2. AMENDMENT/MODIFICATION NO. 0001	3. EFFECTIVE DATE See Block 16C	4. REQUISITION/PURCHASE REQ. NO.	5. PROJECT NO. (If applicable)
---------------------------------------	------------------------------------	----------------------------------	--------------------------------

The purpose of this amendment is to incorporate the following changes/updates in response to questions received from the RFP:

Stennis Space Center Test Complex Nitrogen System Analysis

AB and E Complex Flow Data

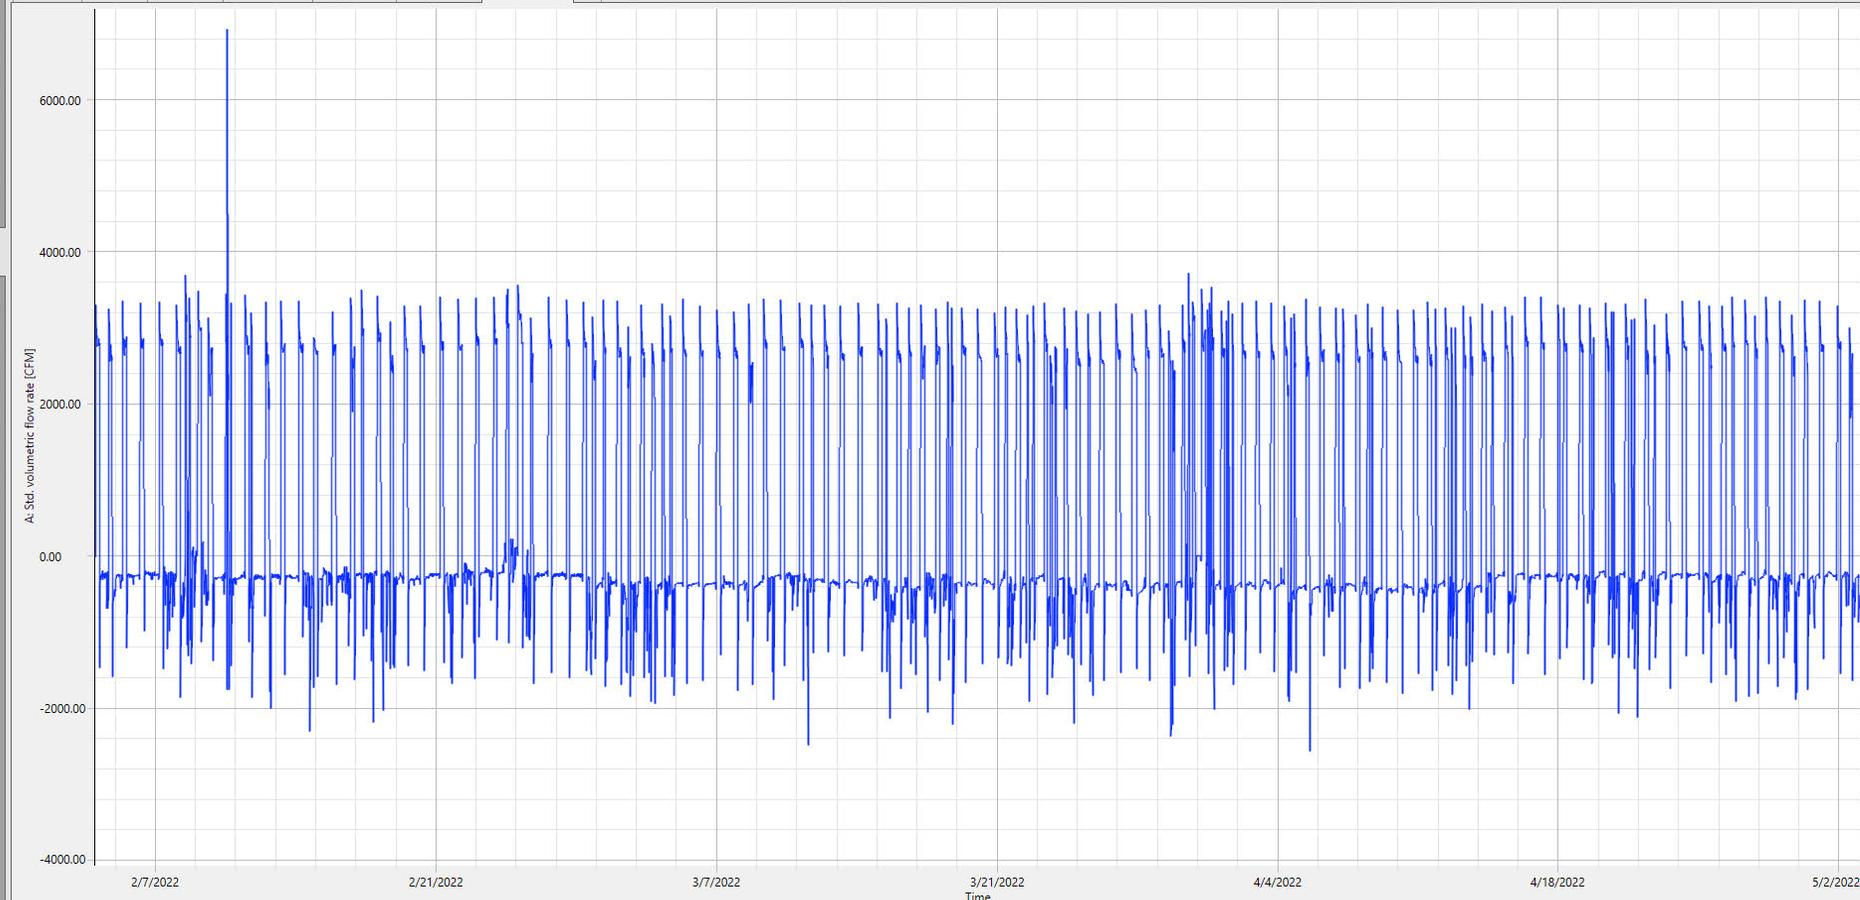
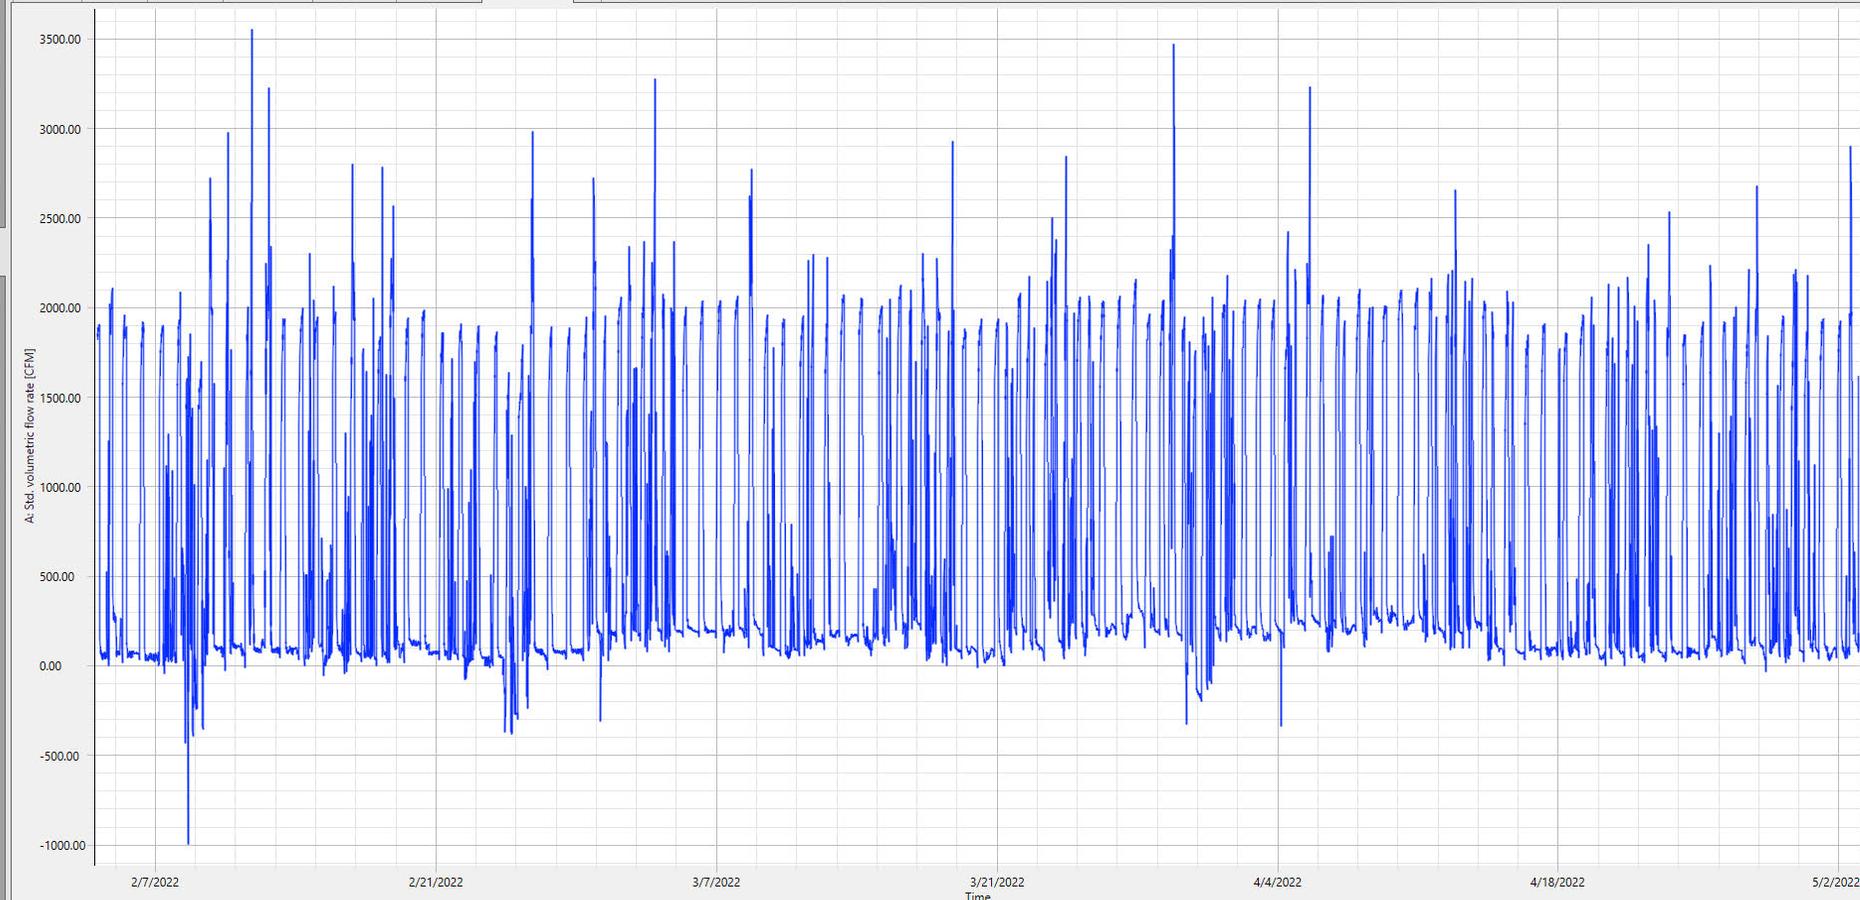
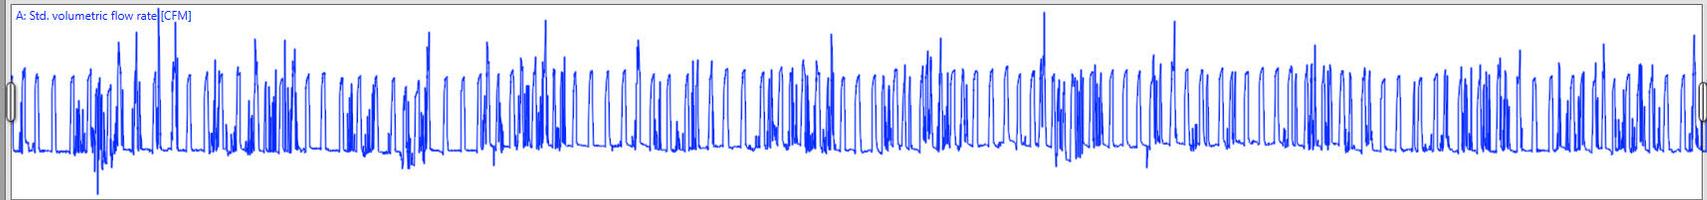
1. Reference Q&A # 8: Added 4 pages
 - (a) Added “AB and E Complex Flow Data” to the end of the attachment
 - (b) Replace initial 1b attachment with the 1b included with this amendment

7		As for the power guarantee, we normally give an annual average based on annual average temperatures and relative humidity (these are the factors that affect compressor power because they affect air density). The power numbers will vary month to month with the seasons and air density, but the annual average should be consistent with our power guarantee. Will we be scored annually or monthly with respect to meeting the power guarantee?	After award and during contract performance, NASA will monitor the power consumption on a continuous monthly basis. If excessive usage is noted that deviates from the "proposed monthly kWh" table, NASA will request a justification.	No change
8	<i>Attachment 1b, Analysis, and Attachment 12, Industry Day Documents</i>	Request NASA provide flow data over a longer period of time than one week. We suggest at least three months. It's our experience that the longer period of data ensures a full understanding of demand both over hours, weeks, months, and instantaneous demands	Yes, NASA will provide additional information. This will be added to the end of Attachment 1b, Analysis (AB and E Complex Flow Data). Data shown represents 3 months of data; the negative values represent back-and-forth flow between East and West test areas (AB and E Test Areas). Also, reference page 5 of 8 in Attachment 1b, Analysis, which shows 13 months of data used at SSC.	Updated Attachment 1b, Analysis
